8th May 2023

Introduction

AirNav Ireland received the below queries from the Department of Transport on 5th May 2023. This document contains a response. For completeness, the appendix contains a response to a related query provided

Diagram 1 – AirNav Ireland illustration of ICAO Requirements as set out in ICAO Doc 9643

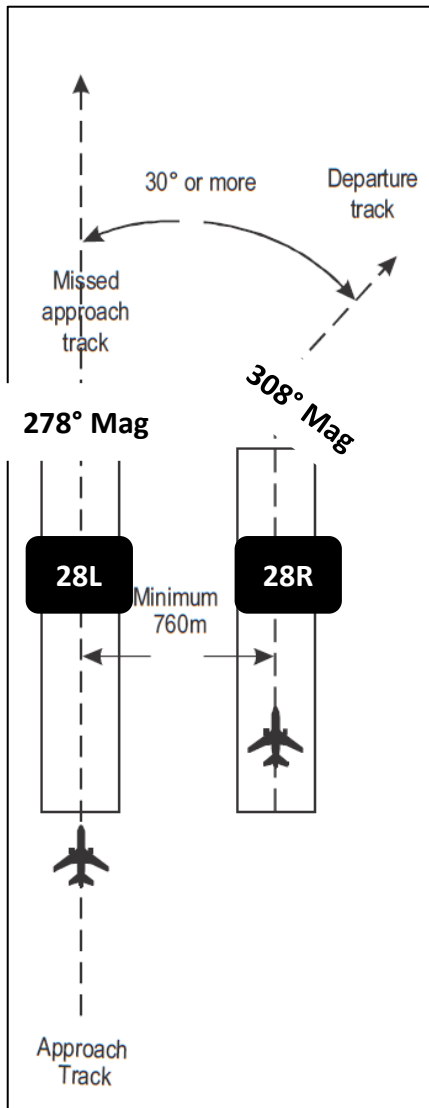
The final regulatory safety reviews before the North Runway became operational stipulated a minimum divergence of 30 degrees off the North Runway in westerly departures:

- 1. Can you give a full, detailed, and technical explanation for this decision?*
- 2. Can you explain why the flight track of the missed approach on the South Runway was not adjusted?*
- 3. Is it possible for the flight track of the missed approach to be adjusted to allow flights from the North Runway to follow a no divergence track in westerly departures?*
- 4. Is it possible for the flight track of the missed approach to be adjusted to allow flights from the North Runway to follow a 15 degree divergence track in westerly departures?*
- 5. The decision shows a 30 degree divergence for westerly departures off the north runway but just a 15 degree divergence for easterly departures. Why is there a difference?*
- 6. It's clear from current flight paths that the divergence is happening closer than was anticipated in the modelling. Why is that the case?*

Diagram 1 below shows the ICAO requirement for where aircraft departing on one runway (RWY28R for Dublin) and an aircraft on final approach to another parallel runway (RWY28L) may be authorised **if the departure course diverges immediately after take-off by at least 30 degrees from the missed approach track of the adjacent approach.**

The magnetic bearing of the two runways is 278 degrees. Therefore, the RWY28R departure track was designed to comply with the 30 degrees minimum divergence requirement.

The relevant reference is ICAO Doc 9643 – Manual on Simultaneous Operations on Parallel or Near-Parallel Instrument Runways (SOIR), Second Edition, 2020.

Note: Dublin Airport Parallel Runways are 1,701m apart.
